# Intel<sup>®</sup> 815E Chipset Platform

Design Guide Update

Document Number: [298249-006](#)

**Figure 75. Clock Routing Topologies**

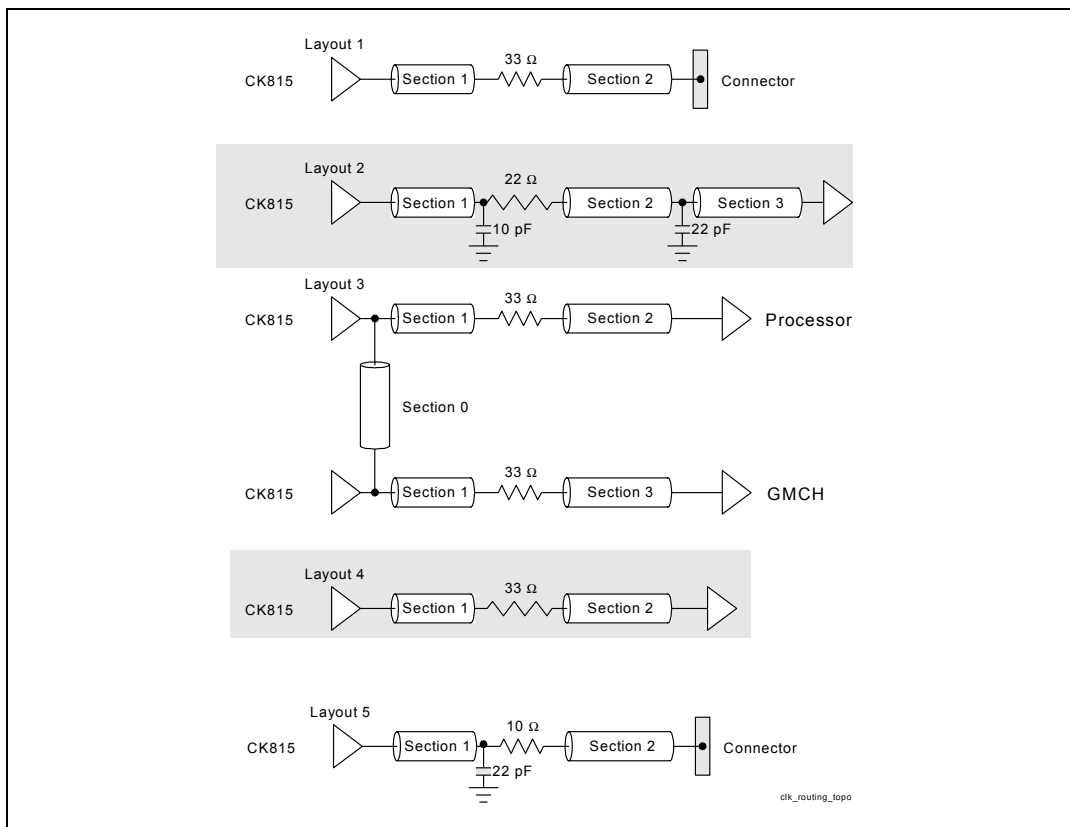
## 1. Changed: Clock Routing Guidelines, Section 11.3; New Layout Guidelines for SDRAM, SCLK, and GMCH HCLK

These new clock guidelines are for future designs to improve PC133 SDRAM Clock Quality. Replace Section 11.3 with the following:

This section presents the generic clock routing guidelines for both 2-DIMM and 3-DIMM boards. For 3-DIMM boards, additional analysis must be performed by the motherboard designer to ensure that the clocks generated by the external PCI clock buffer meet the PCI specifications for clock skew at the receiver, when compared with the PCI clock at the ICH2.

**Figure 54. USB Data Signals**

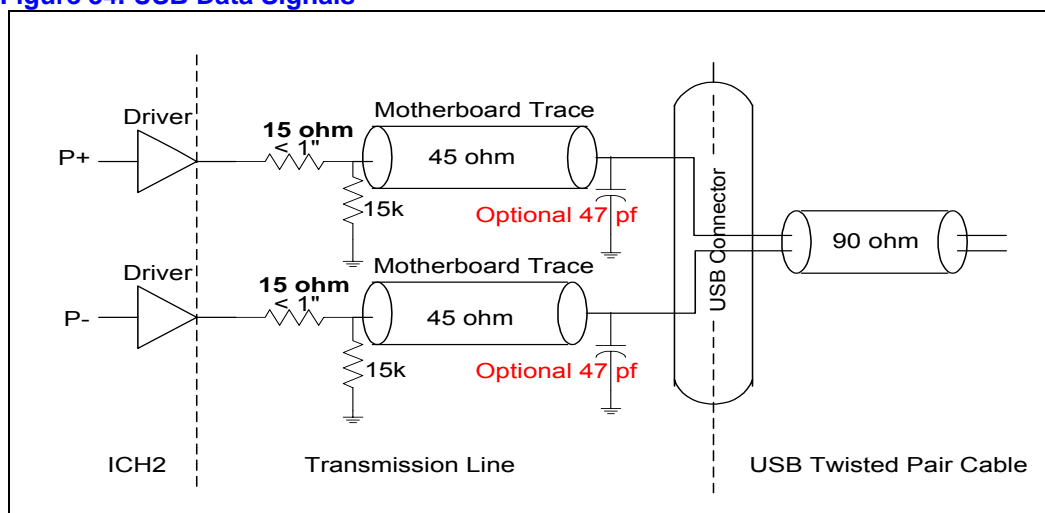
Figure 54, USB Data Signals, page 109, is replaced with the following figure:

**Figure 52.a CDC\_DN\_ENAB# Support Circuitry for a Single Codec on Motherboard**

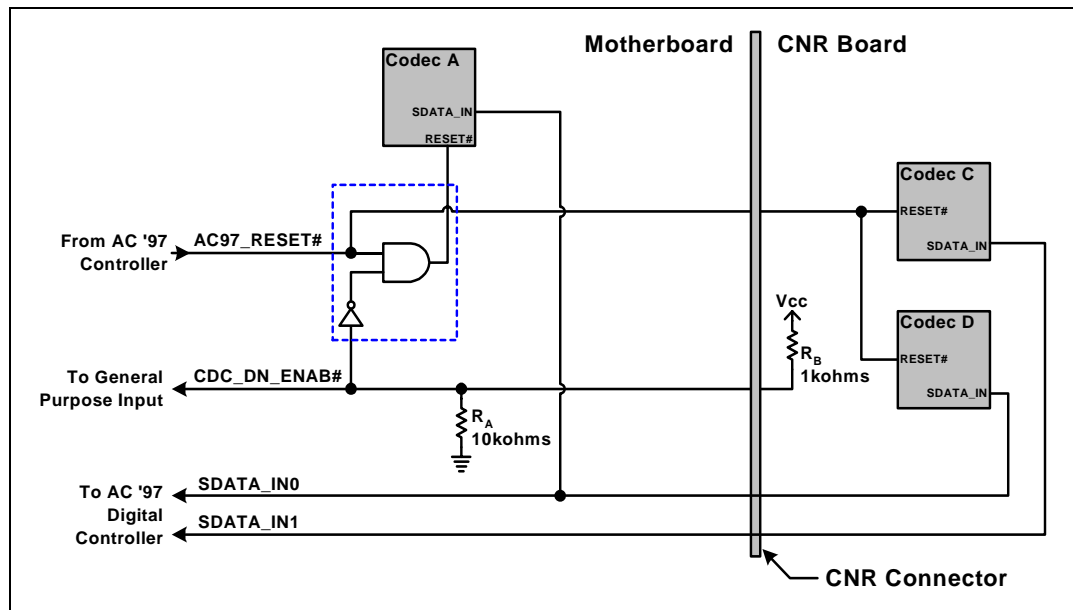
As shown in Figure 52.a, when a single codec is located on the motherboard, the resistor  $R_A$  and the circuitry (AND and NOT gates) shown inside the dashed box must be implemented, on the motherboard. This circuitry is required in order to disable the motherboard codec when a CNR is

**Figure 52.b CDC\_DN\_ENAB# Support Circuitry for Multi-Channel Audio Upgrade**

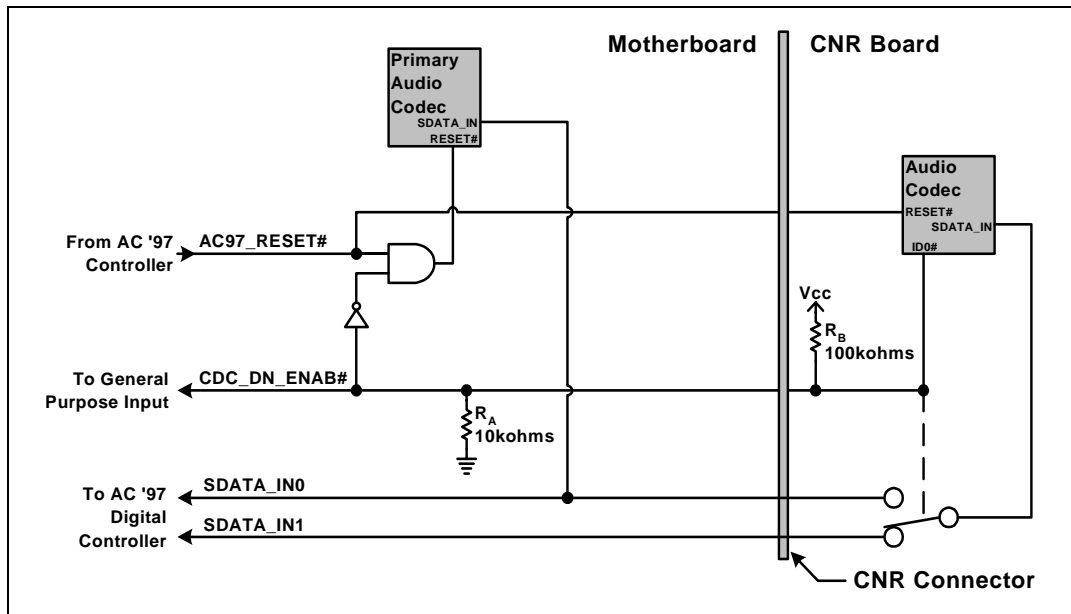
The architecture shown in Figure 52.b has some unique features. These include the possibility of the CNR being used as an upgrade to the existing audio features of the motherboard (by simply changing the value of resistor  $R_B$  on the CNR to 10 k $\Omega$ ). An example of one such upgrade is increasing from two-channel to four or six-channel audio.

Both Figure 52.b and Figure 52.c show a switch on the CNR board. This is necessary to connect the CNR board codec to the proper SDATA\_IN $n$  line as to not conflict with the motherboard codec(s).

**Figure 52.c CDC\_DN\_ENAB# Support Circuitry for Two-Codex on Motherboard / One-Codex on CNR**

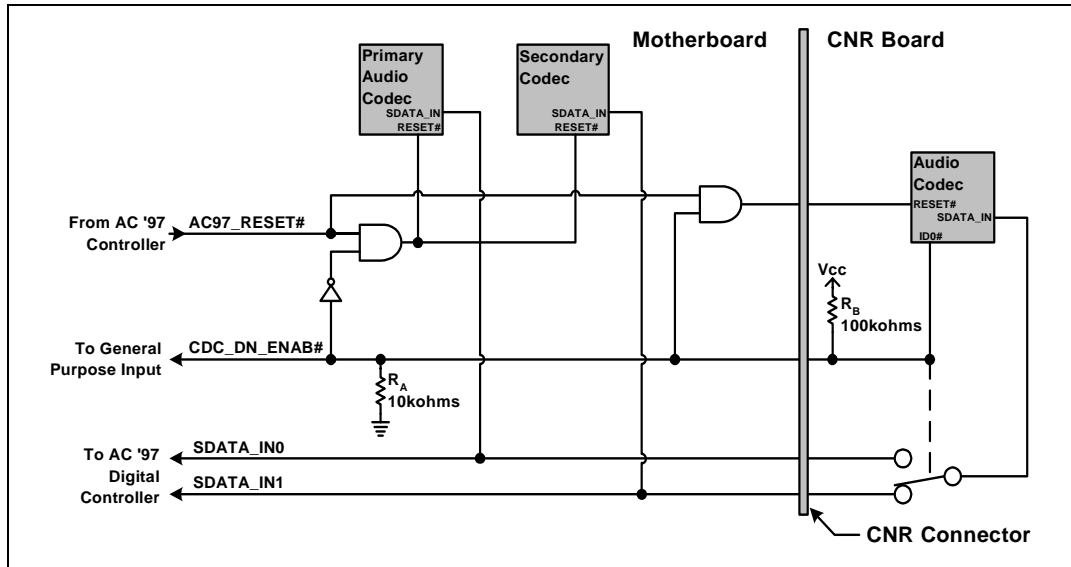
Figure 52.c shows the circuitry required on the motherboard to support a two-codec down configuration. This circuitry disables the codec on a single codec CNR. Notice that in this configuration the resistor,  $R_B$ , has been changed to 100 k $\Omega$ .

**Figure 52.d CDC\_DN\_ENAB# Support Circuitry for Two-Codex on Motherboard / Two-Codex on CNR**

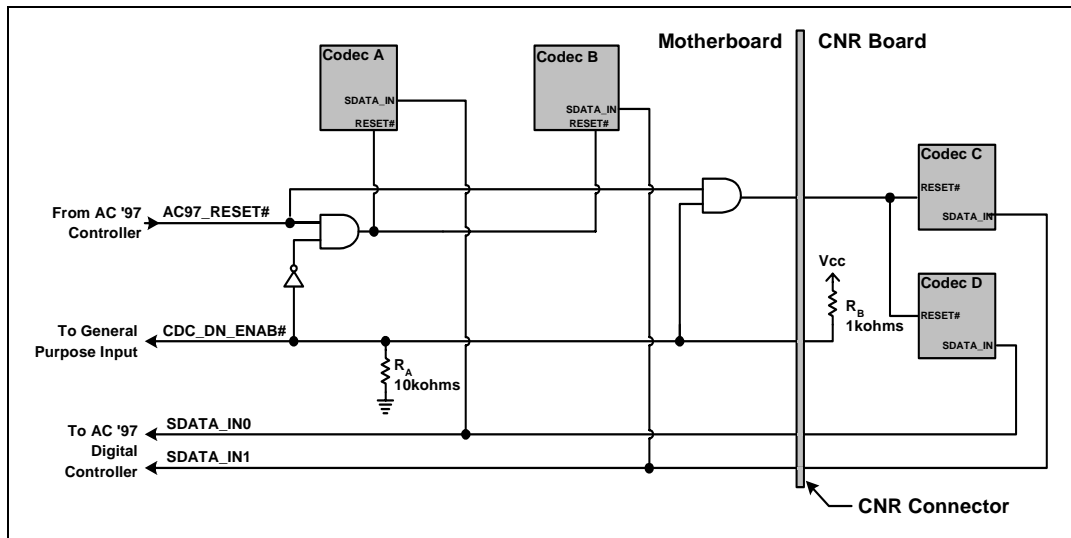
Figure 52.d shows the case of two-codex down and a dual-codec CNR. In this case, both codex on the motherboard are disabled (while both on CNR are active) by  $R_A$  being 10 k $\Omega$  and  $R_B$  being 1 k $\Omega$ .

**Figure 82.a. Example 3.3V/V5REF Sequencing Circuitry**

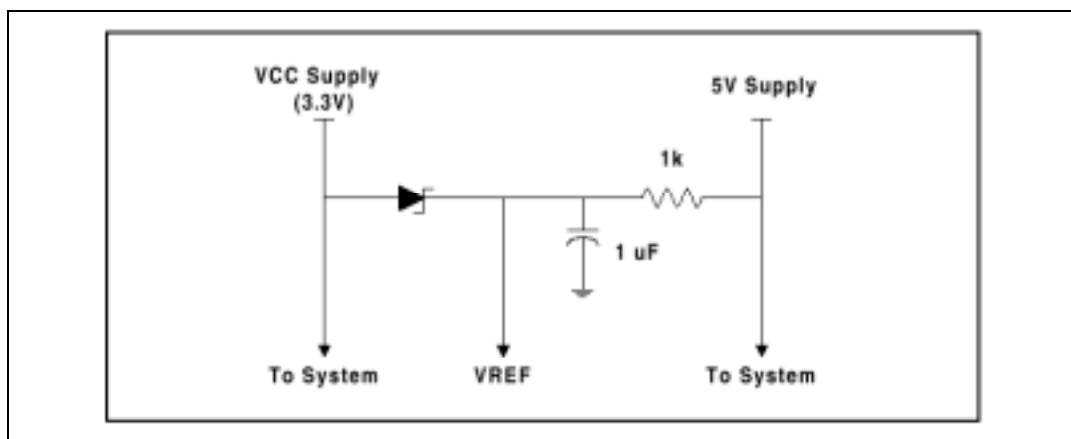
V5REF is the reference voltage for 5V tolerance on inputs to the ICH3. V5REF must be powered up before or simultaneously to VCC3\_3. It must also power down after or simultaneous to VCC3\_3. The rule must be followed in order to ensure the safety of the ICH3. If the rule is violated, internal diodes will attempt to draw power sufficient to damage the diodes from the VCC3\_3 rail. Figure 82.a. shows a sample implementation of how to satisfy the V5REF/3.3V sequencing rule.

**Figure 72.1 FWH VPP Isolation Circuitry**

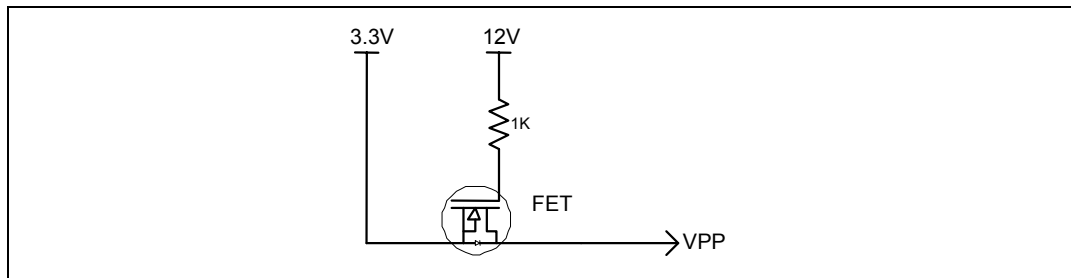
Section 10.12.2, *FWH Vpp Design Guidelines*, has the following paragraph and figure added as shown below:

In some instances, it is desirable to program the FWH during assembly with the device soldered down on the board. In order to decrease programming time it becomes necessary to apply 12 V to the V<sub>PP</sub> pin. The following circuit will allow testers to put 12 V on the V<sub>PP</sub> pin while keeping this voltage separated from the 3.3 V plane to which the rest of the power pins are connected. This circuit also allows the board to operate with 3.3 V on this pin during normal operation.

**Figure 70-1: Intel® 82562ET/EM Disable Circuit**

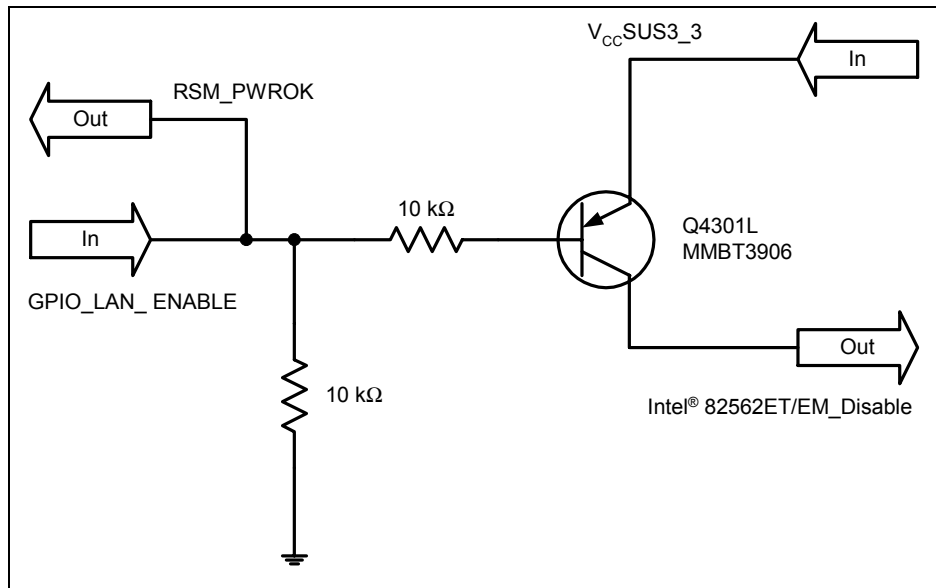
To disable the 82562ET/EM, the device must be isolated (disabled) prior to reset (RSM\_PWROK) asserting. Using a GPIO, such as GPO28 to be LAN\_Enable (enabled high), LAN will default to enabled on initial power-up and after an AC power loss. This circuit shown below will allow this behavior. The BIOS, by controlling the GPIO, can disable the LAN microcontroller.

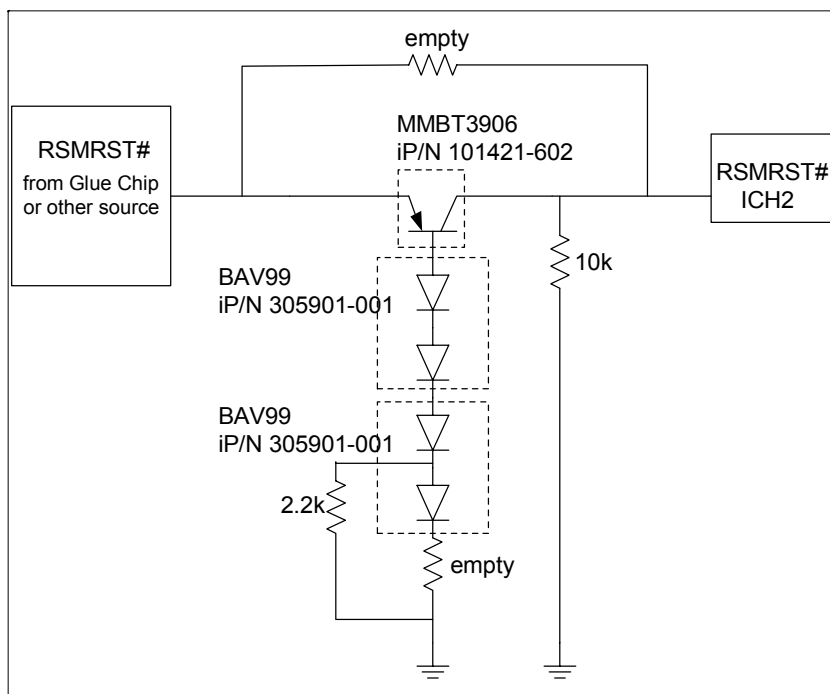
The third bullet in Section 10.5, *USB*, is changed to read as follows:

An optional cap (0 pF – 47 pF) may be placed as close to the USB connector side of the series resistors on the USB data lines (P0+/-, P1+/-, P2+/-, P3+/-). This cap should be sized to minimize EMI radiation while still maintaining signal quality (rise/fall time, Vcrs, etc)."

**Figure 77. Power Delivery Map**

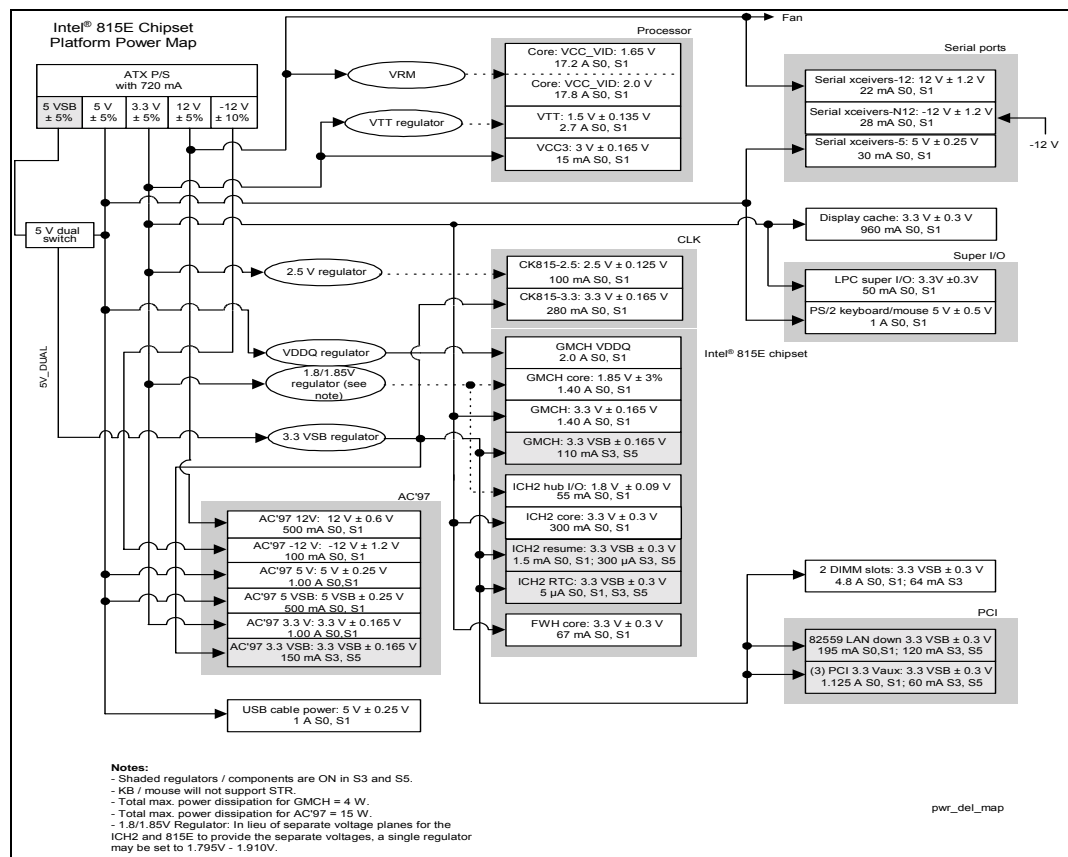
**46. Replaced Figure 77, Power Delivery Map**

Figure 77, Power Delivery Map, is replaced with the following:

**51. Changed Figure 64, Trace Routing, in Section 10.11.2.1, General Trace Routing Considerations**

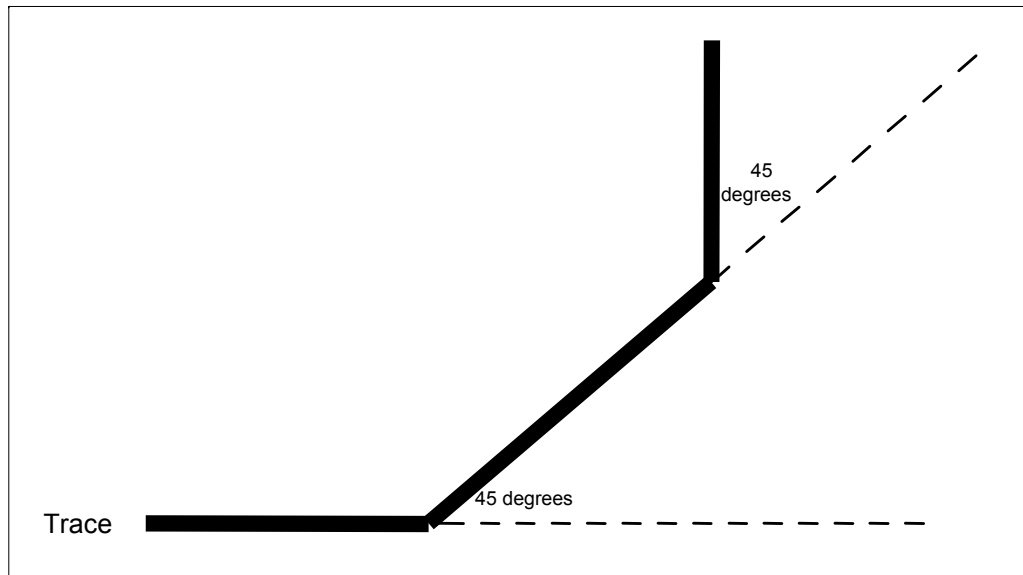
Figure 64, *Trace Routing*, in Section 10.11.2.1, *General Trace Routing Considerations*, is replaced with the following figure:
